STREET LIGHTING ELECTRICAL SITE PLAN

PERMIT SUBMITTAL

COOPERBERRY STREET LIGHTING
4018 10TH STREET EAST
PUYALLUP, WA 98374

LUMINAIRE #	STATION	LUMINAIRE TYPE	MOUNTING HEIGHT	BASE	MAST ARM LENGTH	CITY LUMINAIRE #	COMMENTS
SL1	-	LEOTEK LED #GCJ3-30J-MV-40K-2R-GY-080 (58 WATT)	30'-0"	FIXED	8'-0"	-	
SL2	-	LEOTEK LED #GCJ3-30J-MV-40K-2R-GY-080 (58 WATT)	30'-0"	FIXED	8'-0"	-

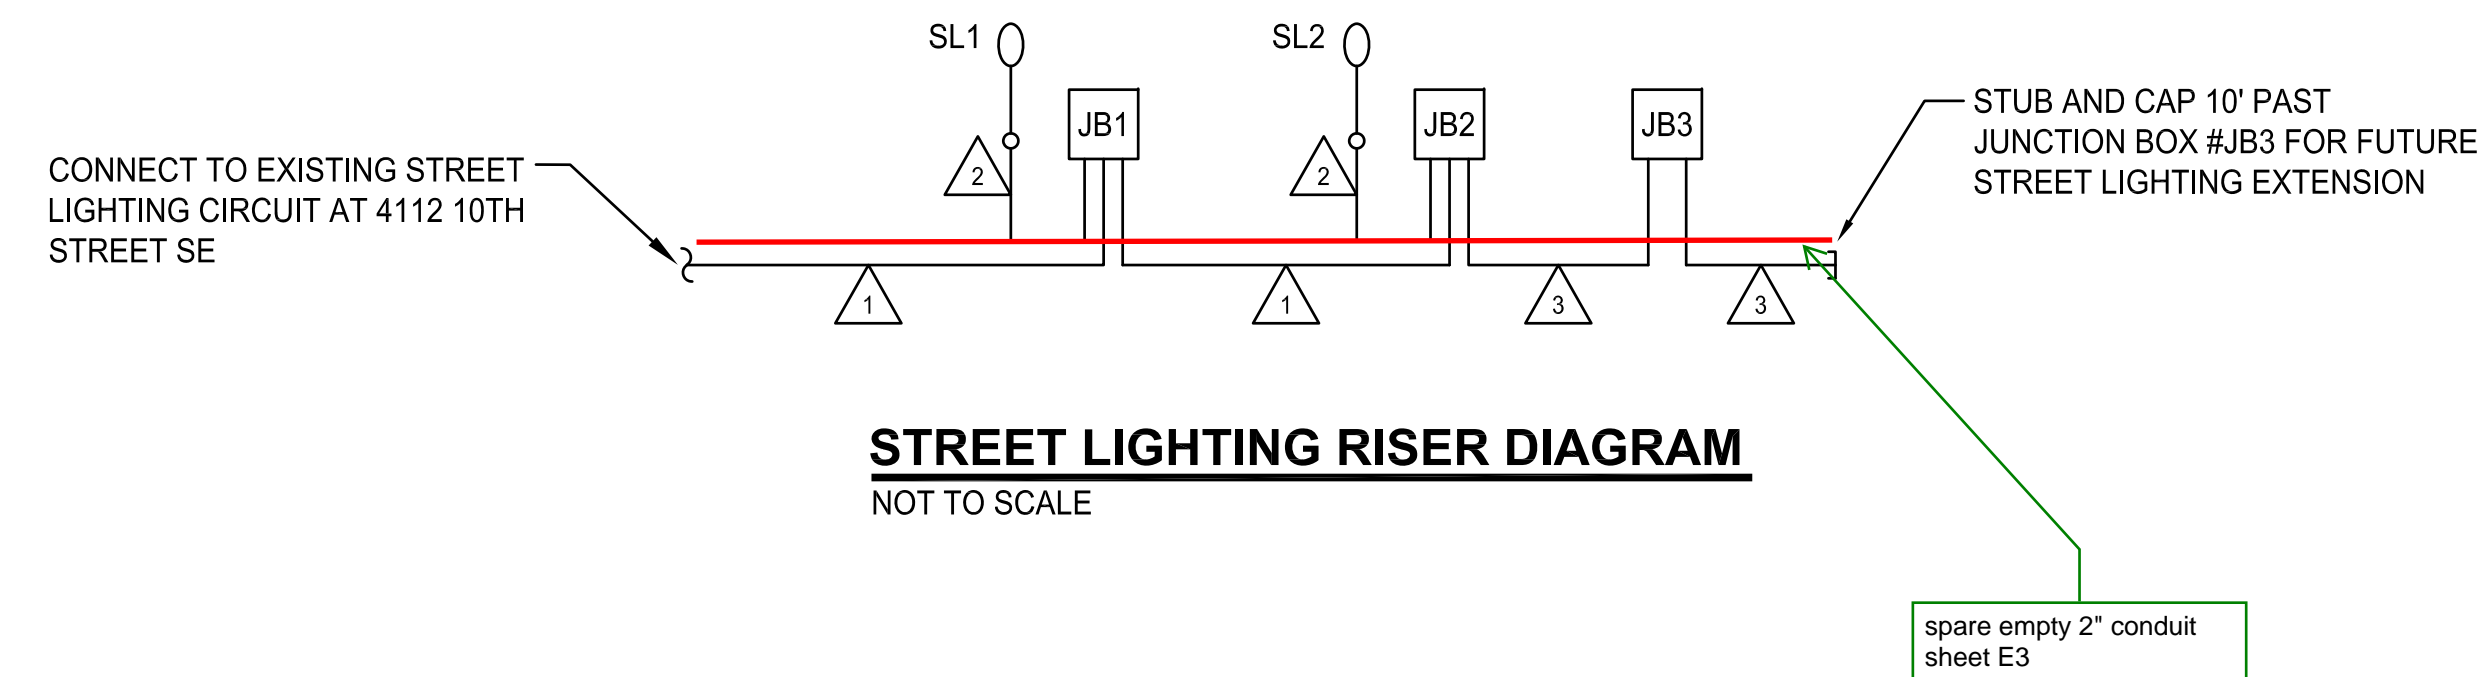
12' mast arm length
E3
